REVIEW OF ANALYSIS OF MECHANISMS FOR EARLY WASTE PACKAGE AND DRIP SHIELD FAILURE

**U.S. Nuclear Regulatory Commission
Contract NRC-02-07-006**

**T. Calvin Tszeng
(Consultant)**

**Center for Nuclear Waste Regulatory Analyses
San Antonio, Texas**

Figure 2-1. Cumulative-Distribution Function for Flaw Size Before Ultrasonic Inspection in Outer Lid Weld. There Are Two Curves in the Figure: One From Bechtel SAIC Company, LLC (2004) and the Other From the Present Calculation.

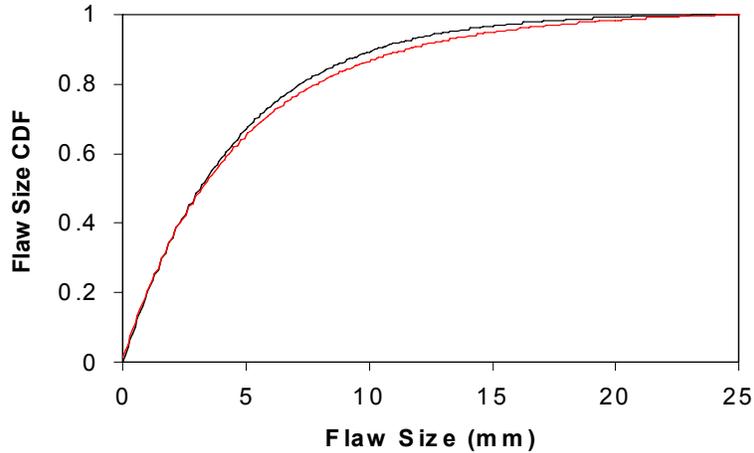
The information provided in Bechtel SAIC Company, LLC (2004, Table 7) is based on the data originally reported in Bechtel SAIC Company, LLC (2003a). These flaw sizes were obtained by an ultrasonic technique that has a best sensitivity of about 1 mm [0.039 in]. The smallest flaw size in the Y-direction reported in Bechtel SAIC Company, LLC (2003a) is 1.6 mm [0.062 in].

Thus, the resulting distribution function of flaw size is actually truncated at 1 mm [0.039 in]; the flaw-size distributions in Figure 2-1 have been extended to zero.

Figure 2-2. The Fraction of Flaws That Have an Angle Greater Than a Certain Value. The Two Curves Correspond to the Mean and 95th Percentile (Close to the Upper Bound).

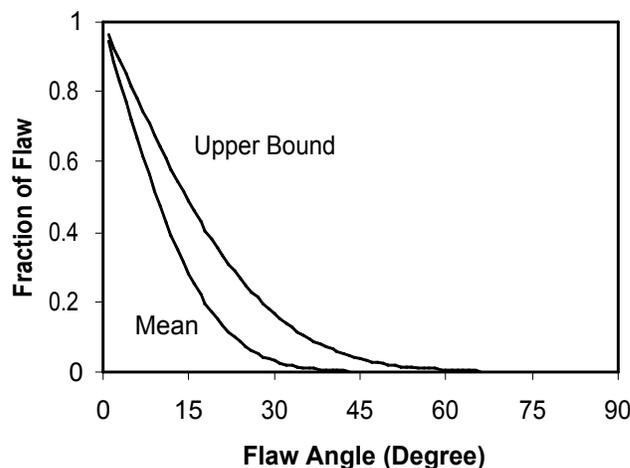
The standard deviation, σ , of the normal distribution is evaluated using the Bayesian approach with a noninformative prior. Based on the seven flaws reported by Bechtel SAIC Company, LLC (2004, Table 7), the mean and 95th-percentile standard variation are determined to be 13.9° and 21.6°, respectively. Based on previous developments, the expected fraction of flaws, F_θ , that has an angle θ greater than 45° is calculated as

Attachment I to be correct. Additional confirmation of the calculation can be established by using the mean value of the standard deviation, σ_m , in Eqs. (2-5) and (2-6). In this case, $F_\theta \approx 1 - P_\theta(\theta, \sigma_m)$. The calculated fraction of flaws with angles, θ , greater than 45° is 0.12 percent, which is in the same order of magnitude of the reported value of 0.8 percent. Using the mean and 95th-percentile standard variation, the fraction of flaws having an angle greater than a certain value was calculated (Figure 2-2). At the 95th percentile, 3.7 percent of flaws have angles greater than 45° . Overall, CNWRA confirmed the conclusion that almost all the flaws are in the direction of the weld. Flaws that are radially oriented (i.e., making an angle of 45° or more with respect to the direction of the weld) represent less than a median value of 1 percent of the total.
